REPORT TO APPLICATION DETERMINATION PANEL
Meeting held on 31 March 2016

145 Old Pittwater Road Brookvale, 2741 / 9999 Condamine Street Manly Vale, 75 Old Pittwater Road Brookvale, 2742 / 9999 Condamine Street Manly Vale, 30 / 0 Old Pittwater Road Brookvale - Modification of Development Consent DA2008/1742 granted for Construction of stormwater upgrade works for Warringah Mall and watercourse bank stabilisation works

APPLICATION FOR MODIFICATION ASSESSMENT REPORT

Application Number:	Mod2015/0247
Responsible Officer:	Adam Mitchell
Land to be developed (Address):	Lot 100 DP 1015283, 145 Old Pittwater Road BROOKVALE NSW 2100 Lot 2741 DP 752038, 2741 / 9999 Condamine Street MANLY VALE NSW 2093 Lot 2 DP 600059, 75 Old Pittwater Road BROOKVALE NSW 2100 Lot 2742 DP 752038, 2742 / 9999 Condamine Street MANLY VALE NSW 2093 Lot 30 DP 204107, 30 / 0 Old Pittwater Road BROOKVALE NSW 2100
Proposed Development:	Modification of Development Consent DA2008/1742 granted for Construction of stormwater upgrade works for Warringah Mall and watercourse bank stabilisation works
Zoning:	LEP - Land zoned B3 Commercial Core LEP - Land zoned IN1 General Industrial LEP - Land zoned IN1 General Industrial LE

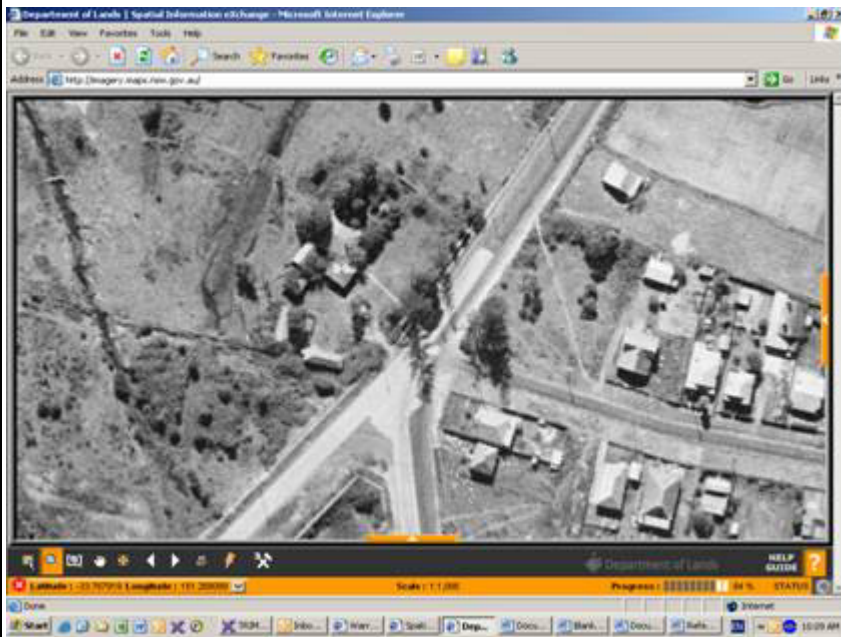
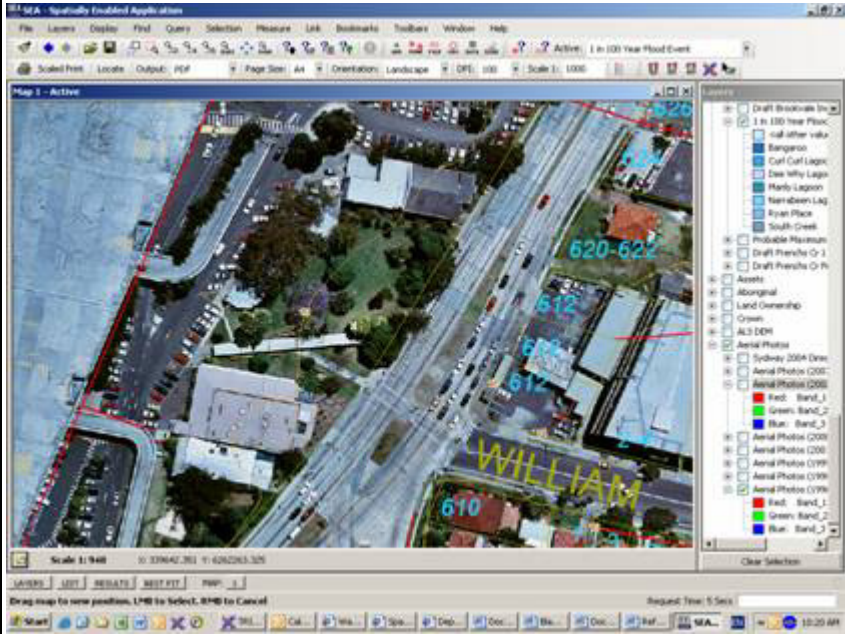
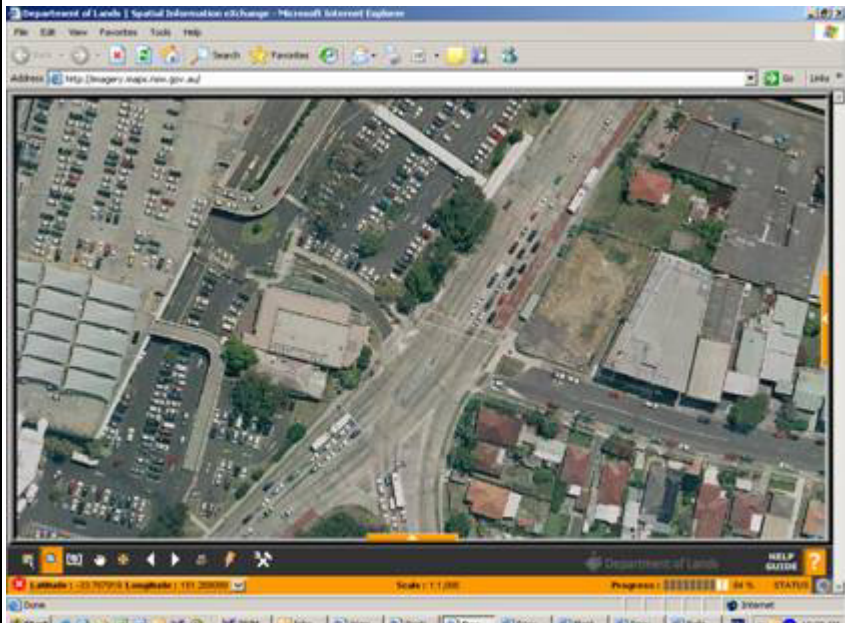
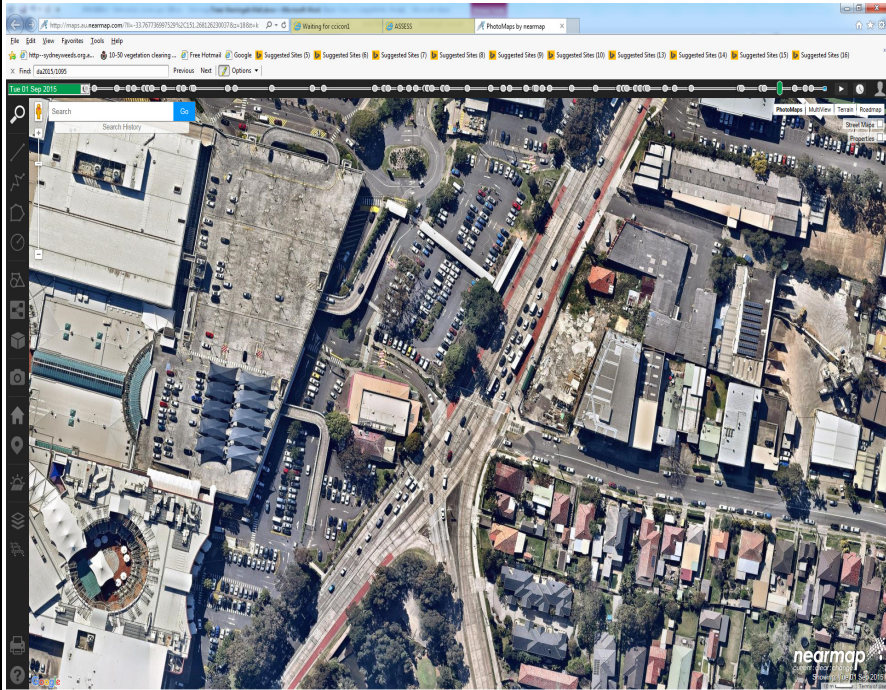
The issue raised previously was the cultural significance of the trees, which include Norfolk (*Araucaria heterophylla*), Brush Box (*Lophostemon conferta*) and Fig (*Ficus rubiginosa*).

Review of air photos from 1943 indicate the presence of vegetation including Norfolk Island location. Images from 1910 obtained through Council's Library Service indicate Norfolk Island similar location forward of Brookvale House. The planting may therefore be remnants of the gardens.

As a long standing landscape element that appears to pre-date the Warringah Mall and has existed during its existence, the trees are considered significant enough to warrant retention.

In the event that no alternative can be engineered, replacement planting should reflect the trees at this location.

No objections are raised to other landscape elements indicated in the scheme, however, the trees behind the bus stop is considered a significant matter to be addressed by the applicant.
